ADDENDUM NUMBER 2

- 1.01 DATE: NOVEMBER 23, 2020**
- 1.02 PROJECT: ELMORE SPORTS MEDICINE RENOVATIONS**
- 1.03 PROJECT NUMBER: DCM NO. 2020452**
- 1.04 OWNER: ALABAMA A&M UNIVERSITY**
- 1.05 ARCHITECT: NOLA | VAN PEURSEM ARCHITECTS, PC**

U.L. DESIGN #L524
A-0.1 NOT TO SCALE

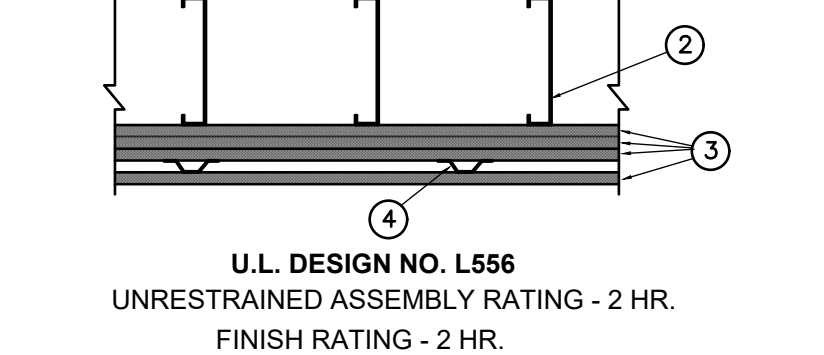
- A. Replace this sheet in its entirety. Revisions include the following:
 - 1. Added U.L. Design #U419
 - 2. Added U.L. Design #L556
 - 3. Added U.L. Design #L524

PARTIAL MEZZANINE DEMO PLAN

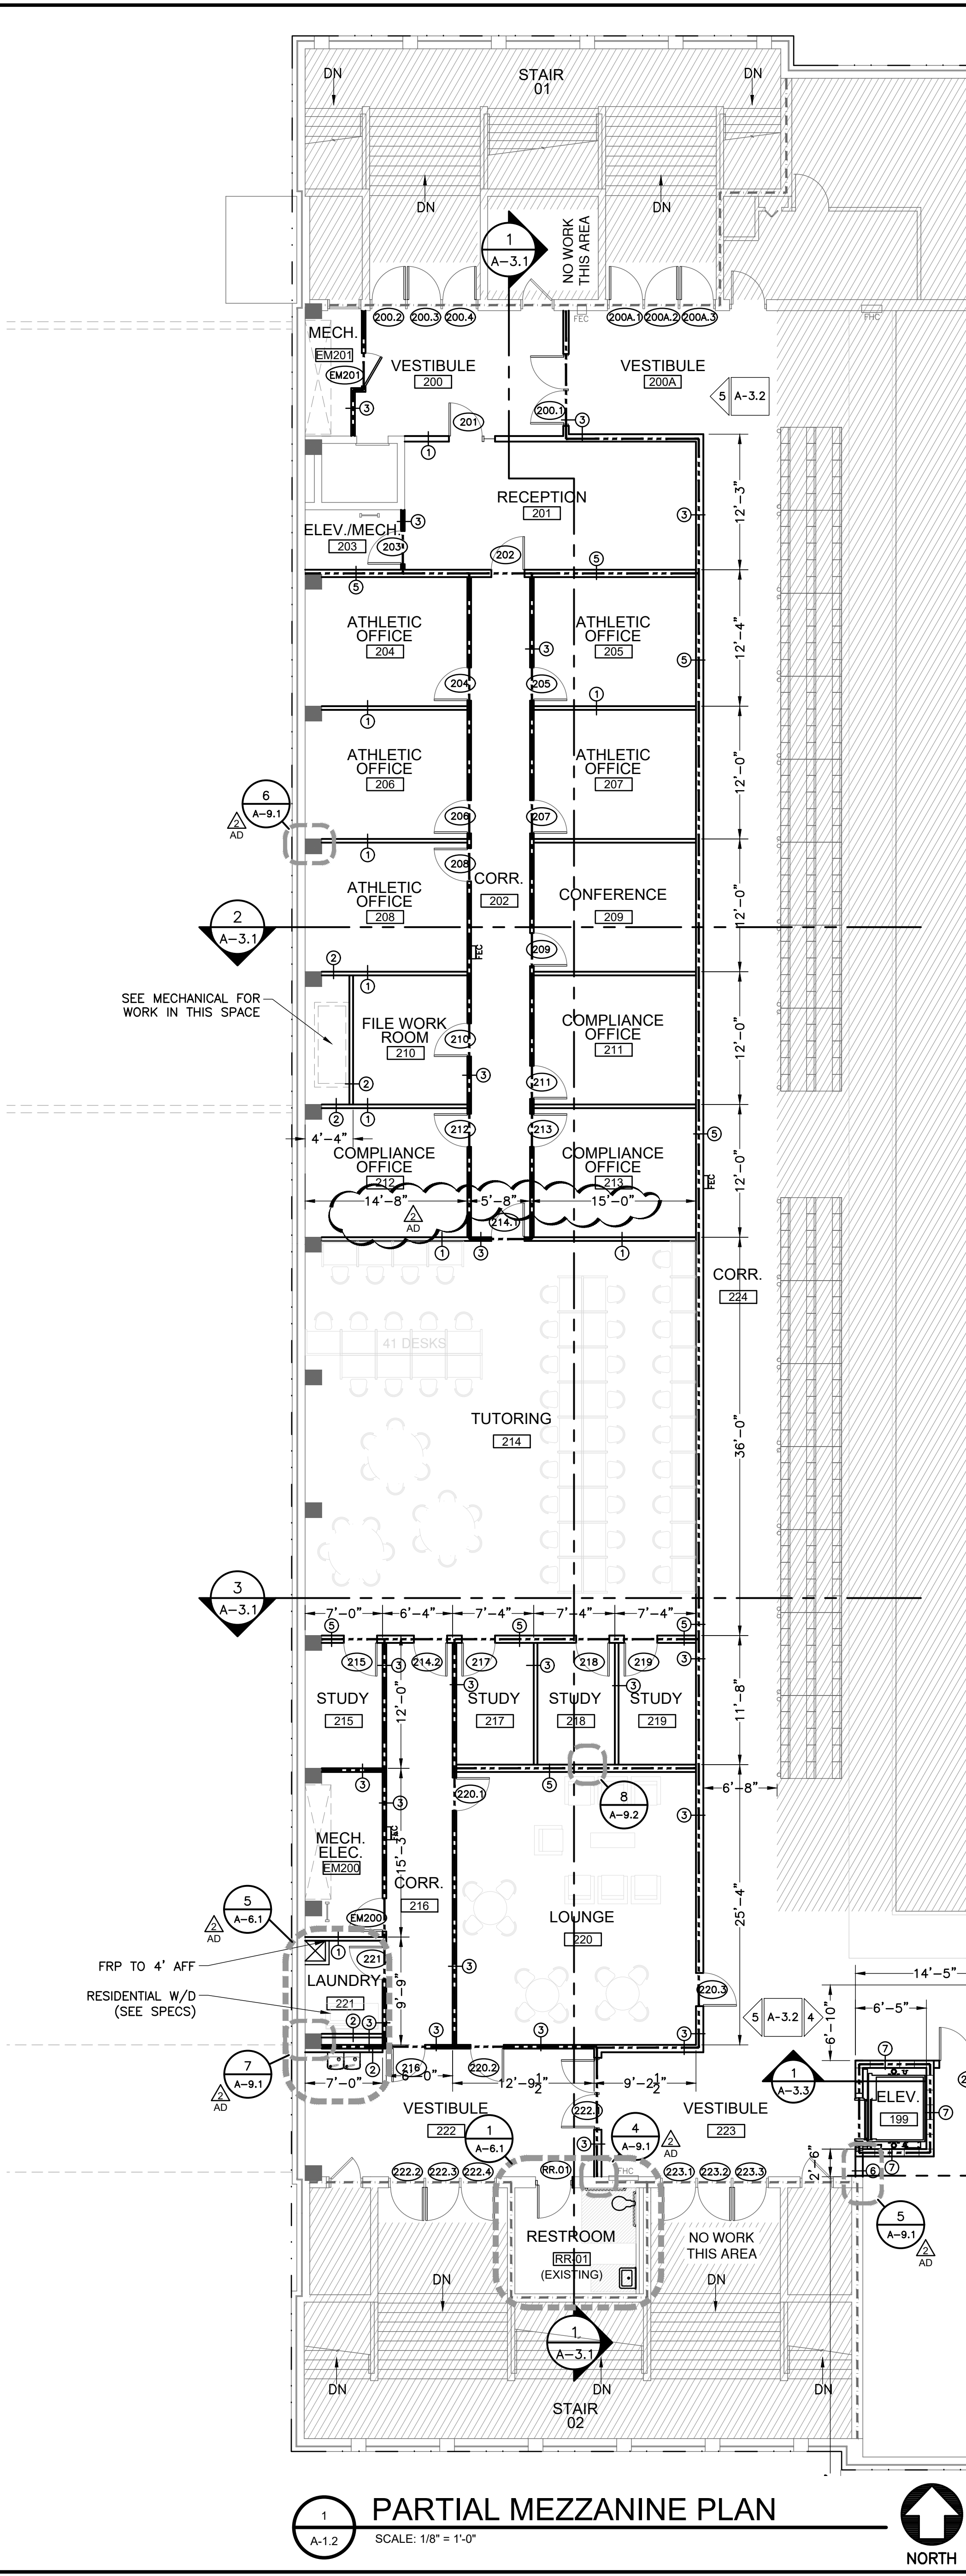
- A. Replace this sheet in its entirety. Revisions include the following:
 - 1. Added hatch to area of existing terrazzo to be removed and replaced.

1
A-1.2
PARTIAL MEZZANINE PLAN
SCALE: 1/8" = 1'-0"
NORTH

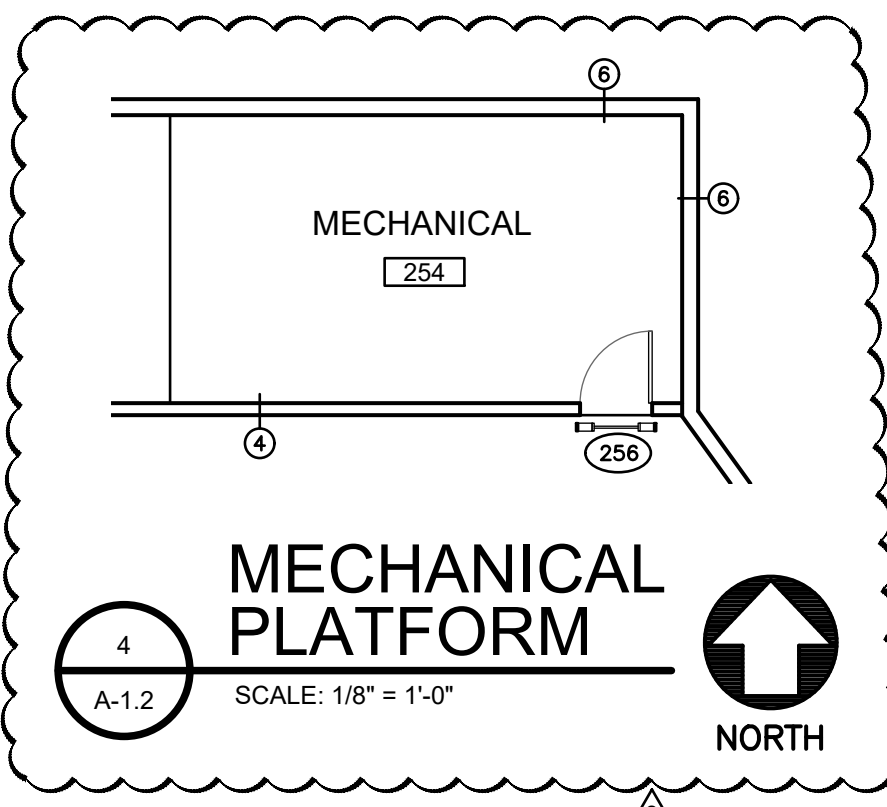
- A. Replace this sheet in its entirety. Revisions include the following:
 - 1. Added additional dimensions to Partial Mezzanine Plan.
 - 2. Revised tags referencing sheet A-9.2 to reference A-9.1.
 - 3. Added enlarged plan tag 5/A-6.1 for enlarged laundry room.
 - 4. Added mechanical platform plan.

SHEET NUMBER
A-3.2
OF

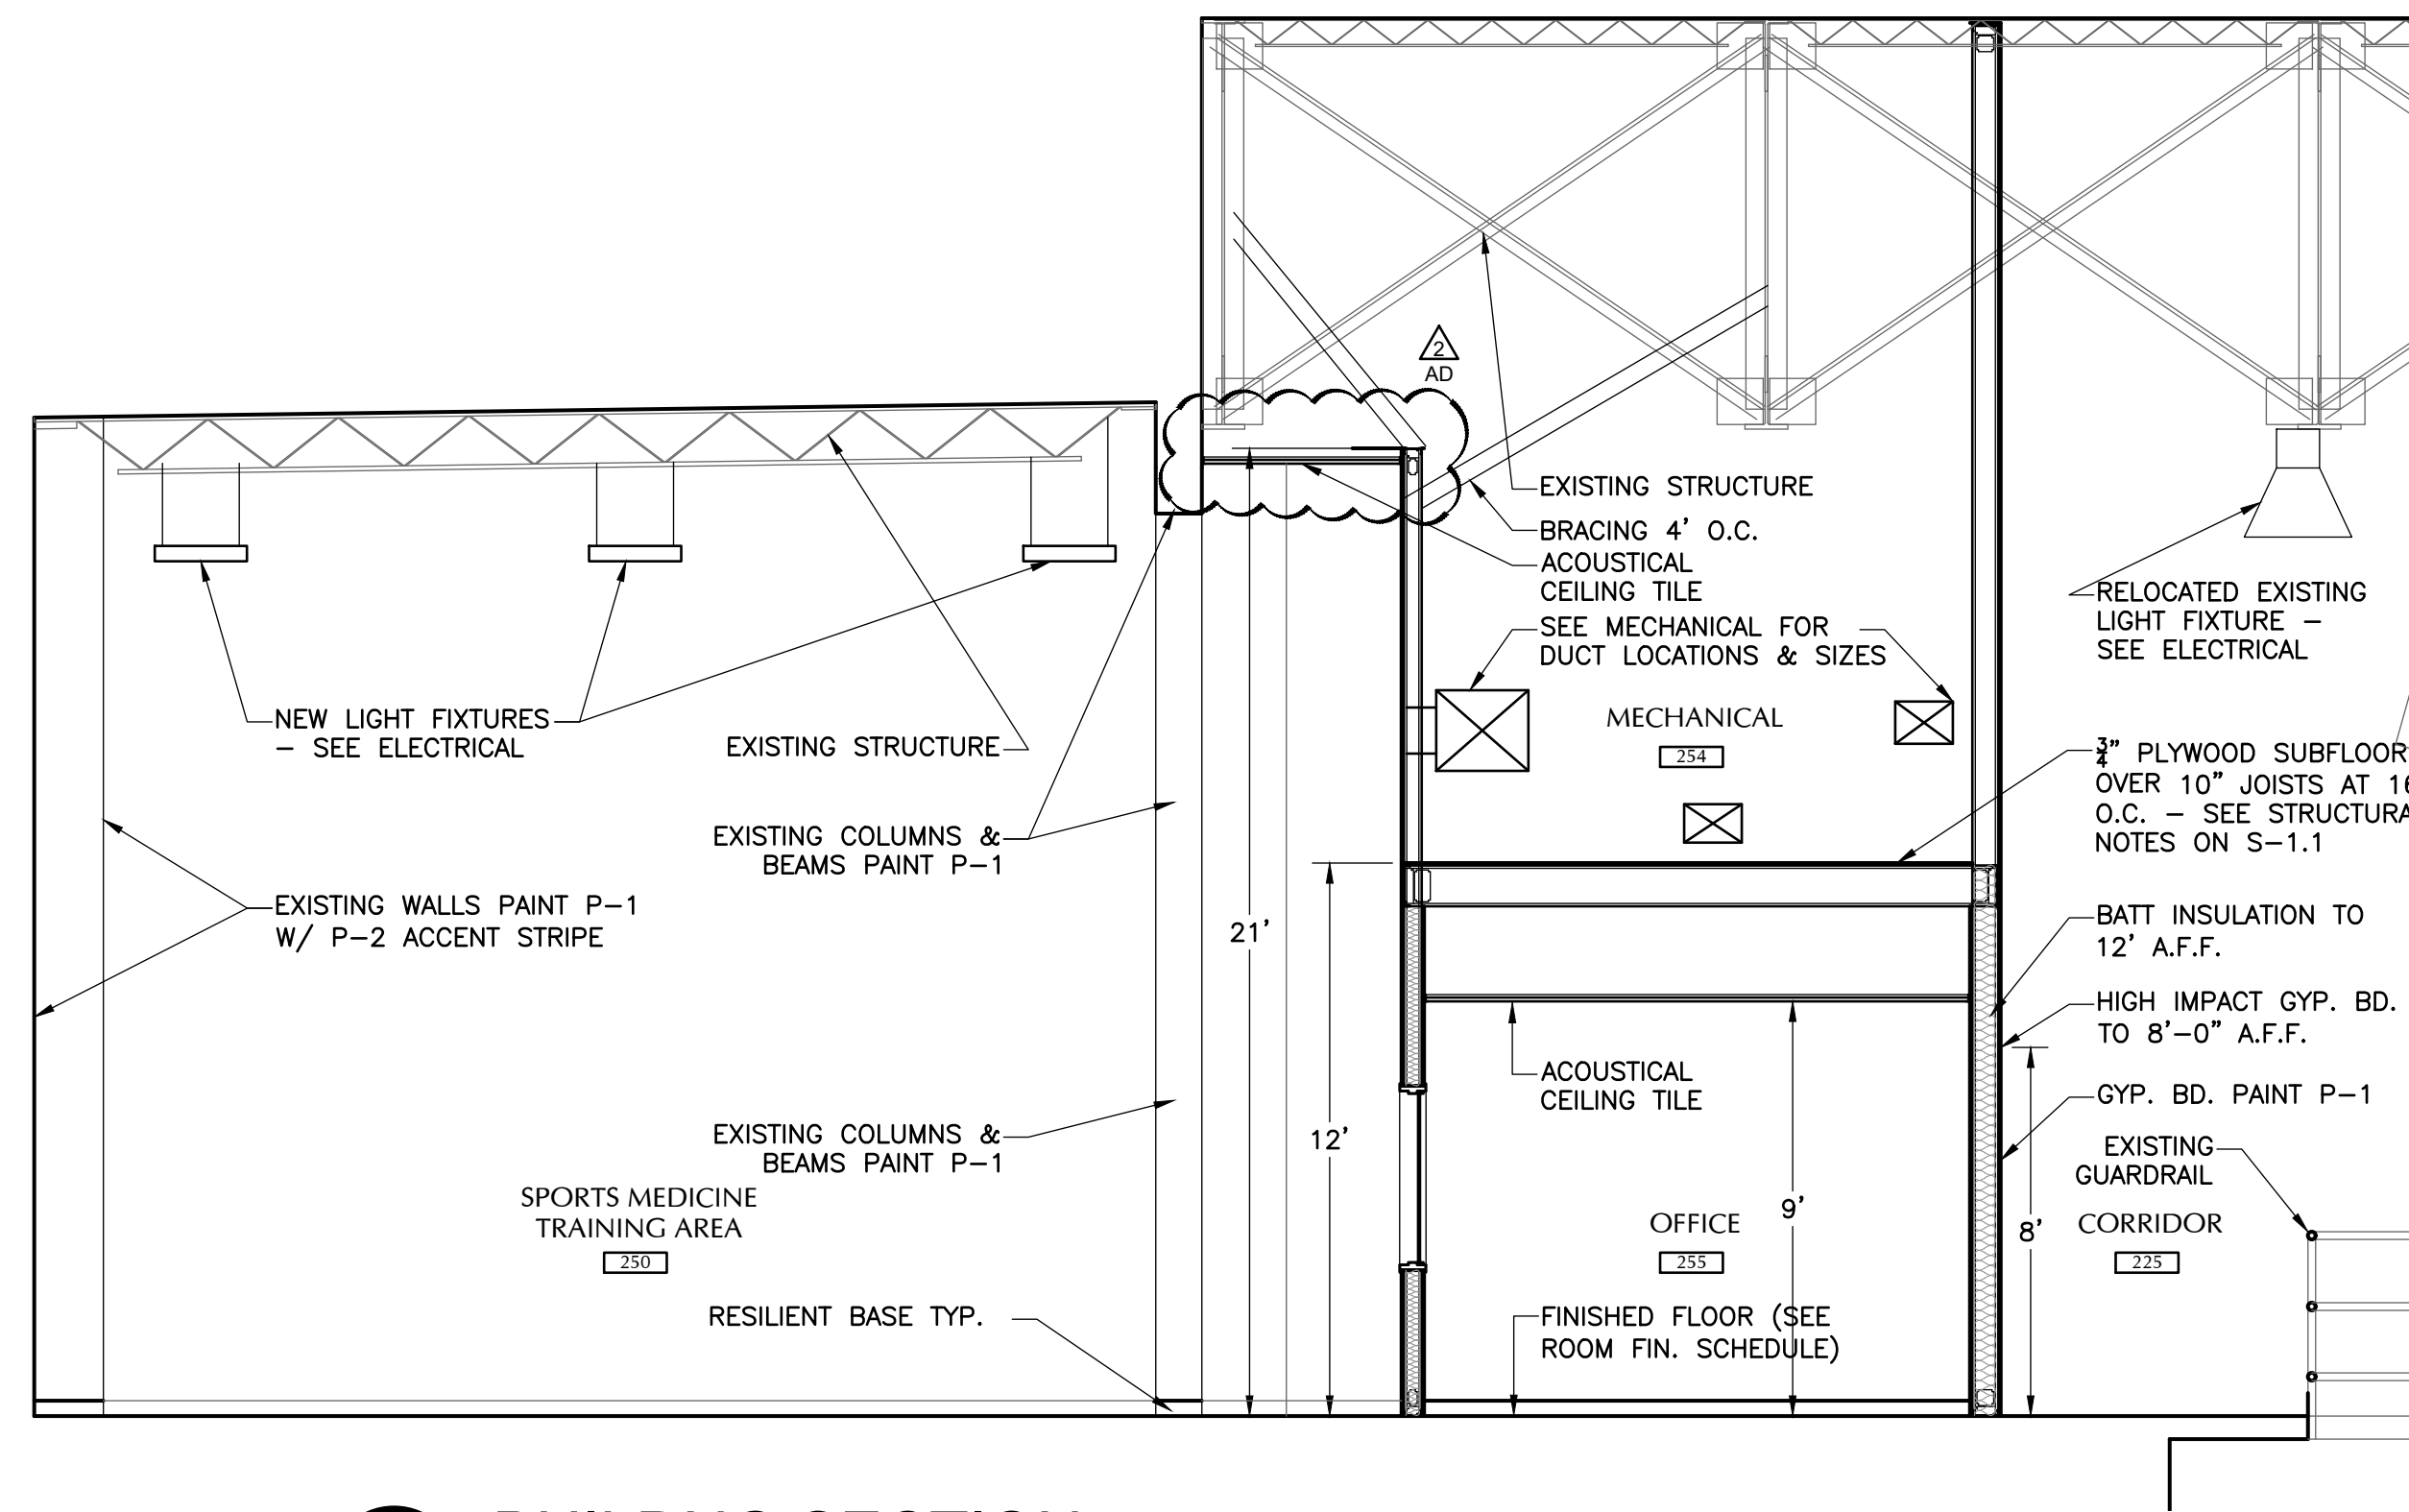
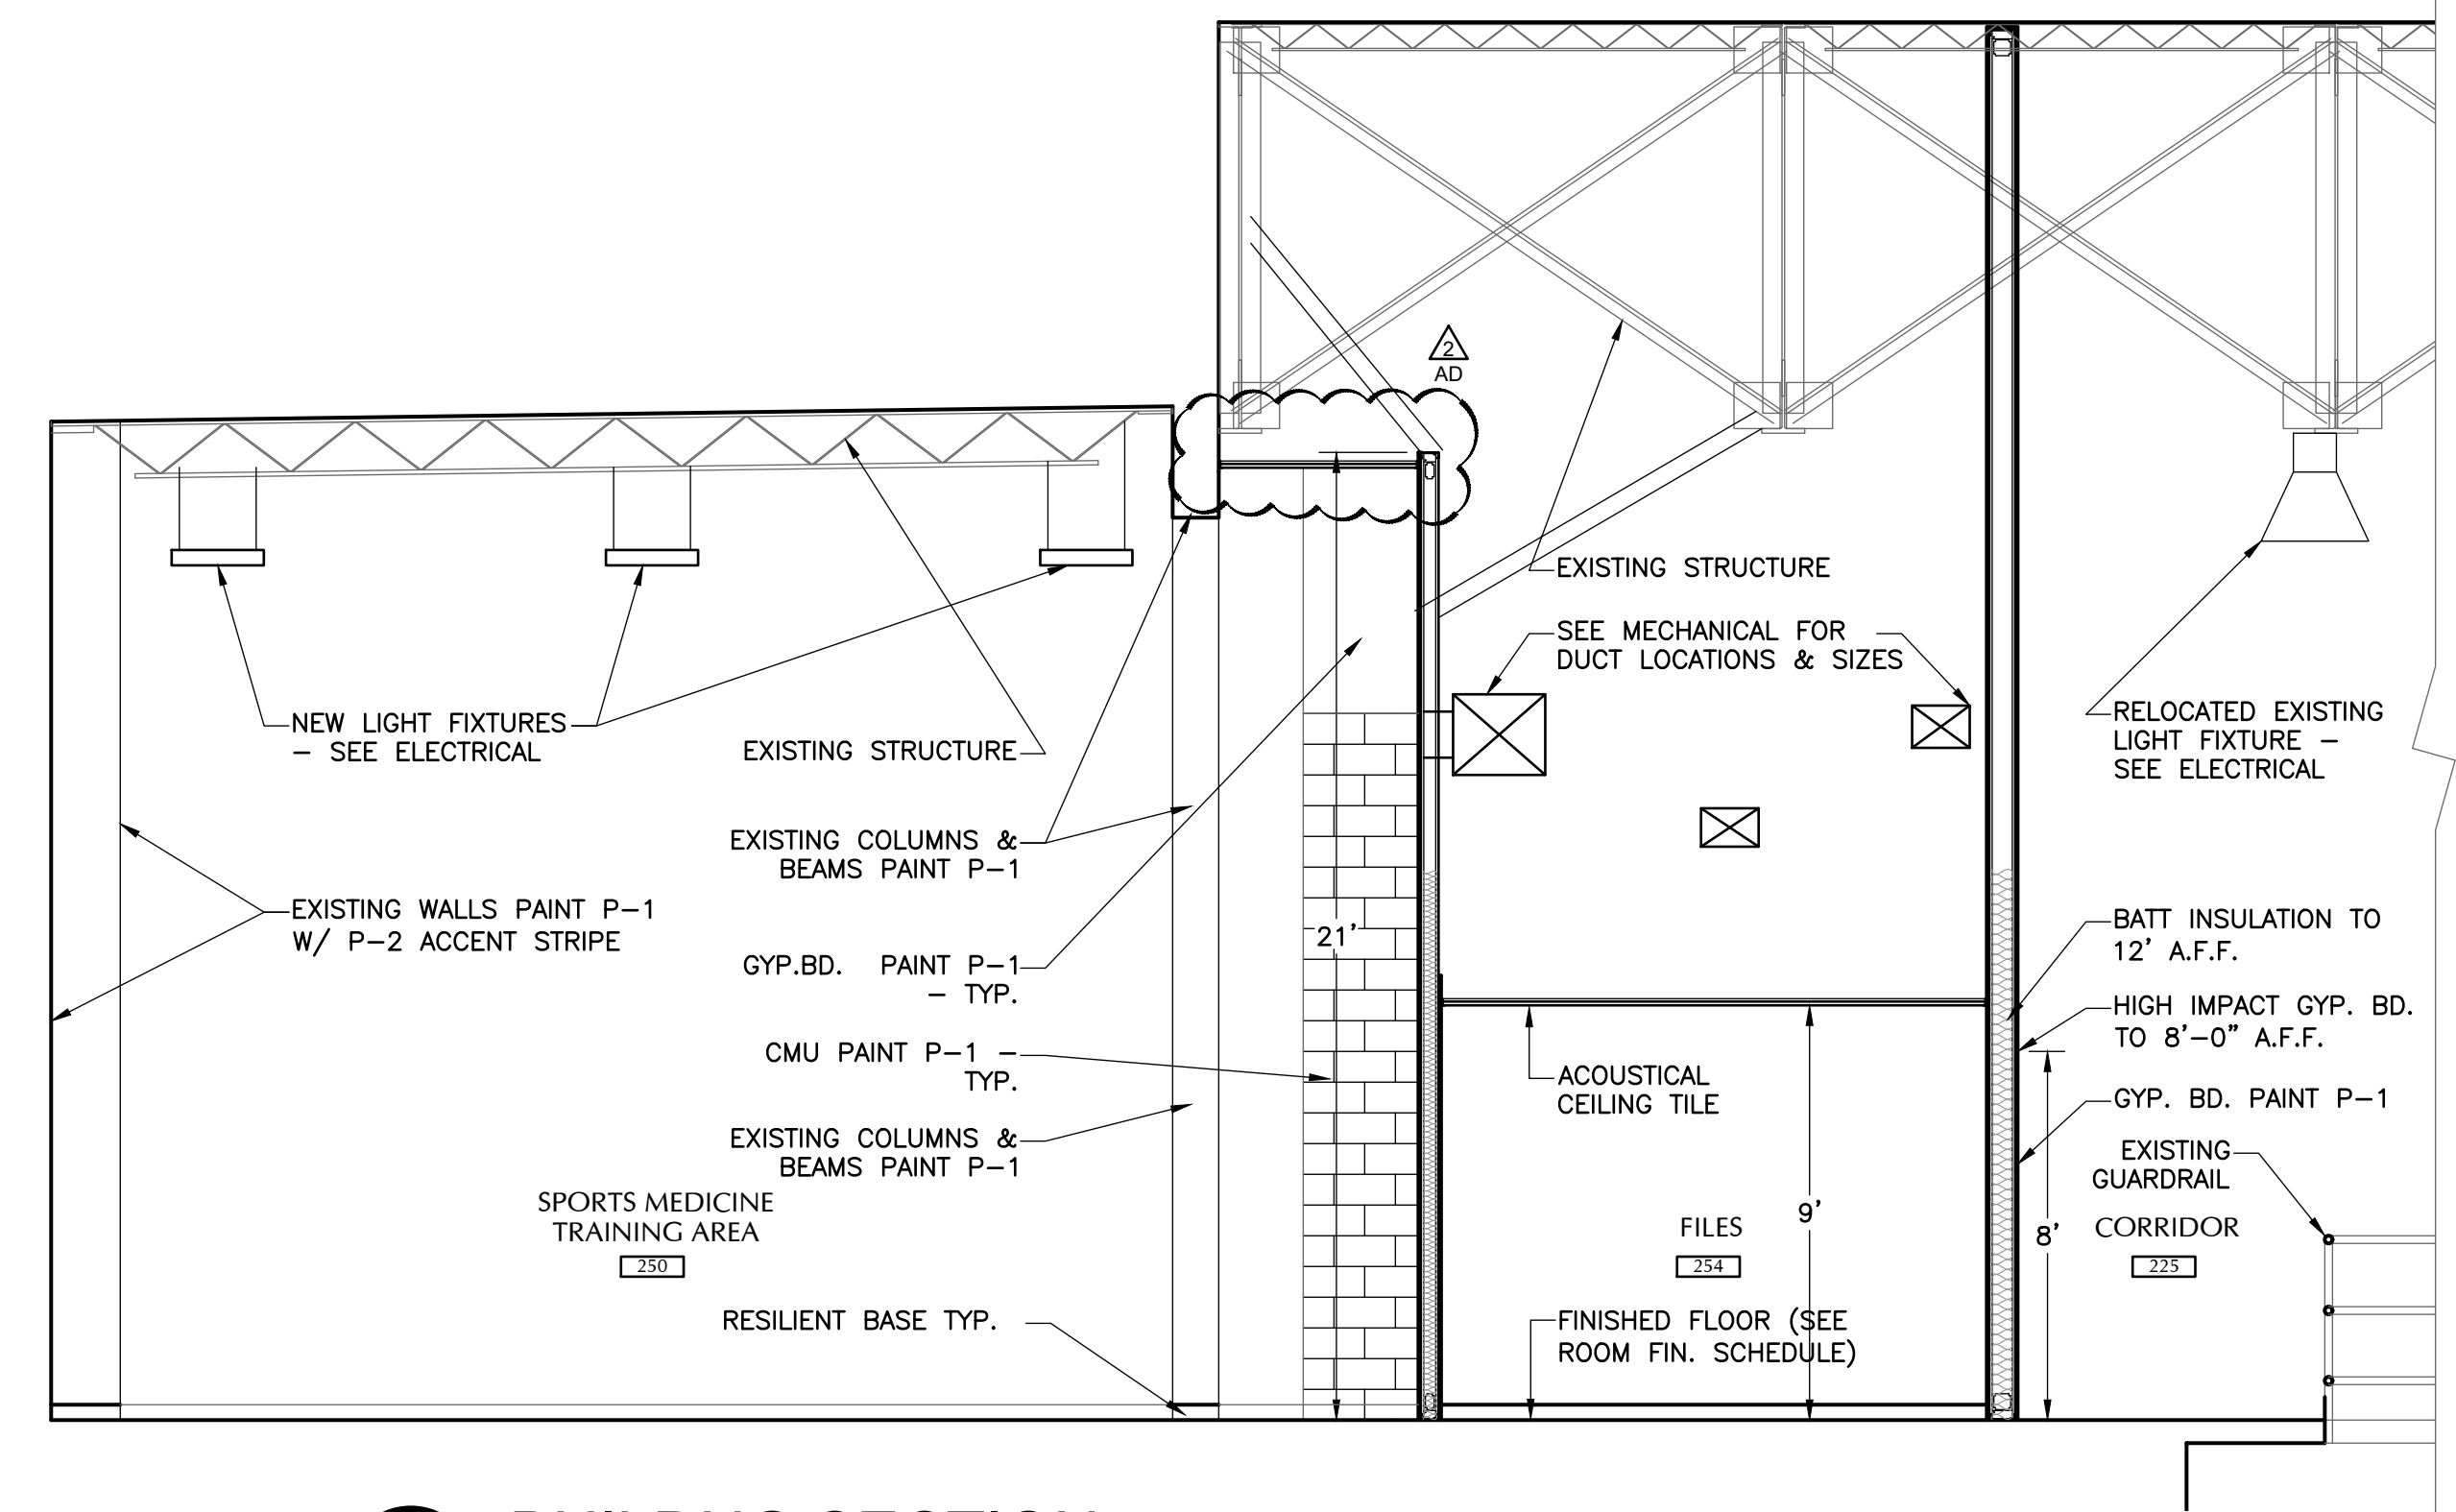
- A. Replace this sheet in its entirety. Revisions include the following:
 - 1. Added acoustical ceiling to portion of sports medicine training area.
 - 2. Added attachment note to typical steel ladder detail.
